Service Bulletin 598

Subject: Rear Bevel Box Breather				
Bulletin Number	Models Affected	VIN Range		Markets Affected
598	Tiger 1200 GT	From AV5527	To BD8324	All Markets
	Tiger 1200 GT Pro			
	Tiger 1200 Rally Pro			
	Tiger 1200 GT Explorer			
	Tiger 1200 Rally Explorer

1. Rear bevel box breather

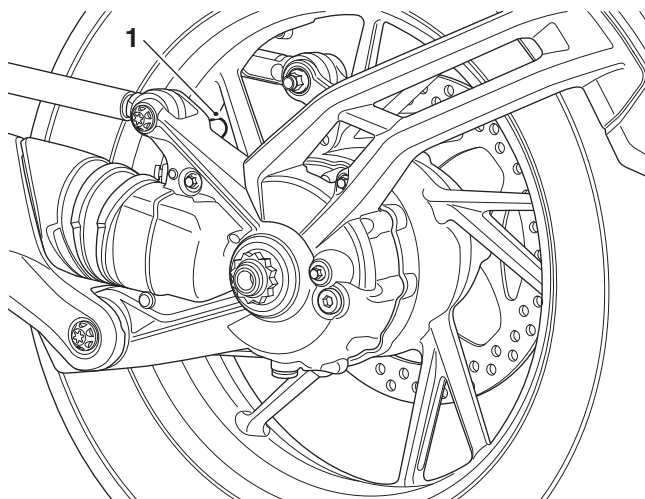
1. Remove the rear bevel box breather from the rear bevel box, noting the position of the locating tang for installation.

- 1. Rear bevel box breather
- 2. Locating tang
- 3. Sealant
- 4. Sealant not to cross this line

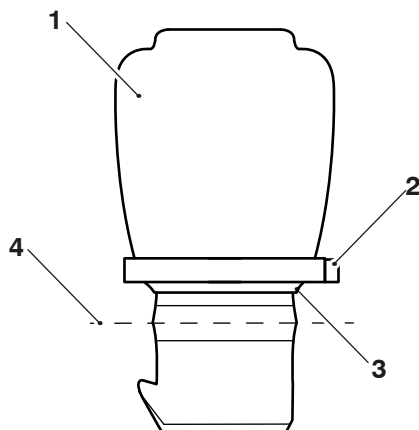
3. Apply Threebond 1216E sealant (or equivalent if not available in market) to the entire circumference in the area shown below. The sealant must not pass the apex of the bead as highlighted by the dotted line on the illustration.

4. Install the rear bevel box breather to the rear bevel box with the locating tang positioned as noted during removal.
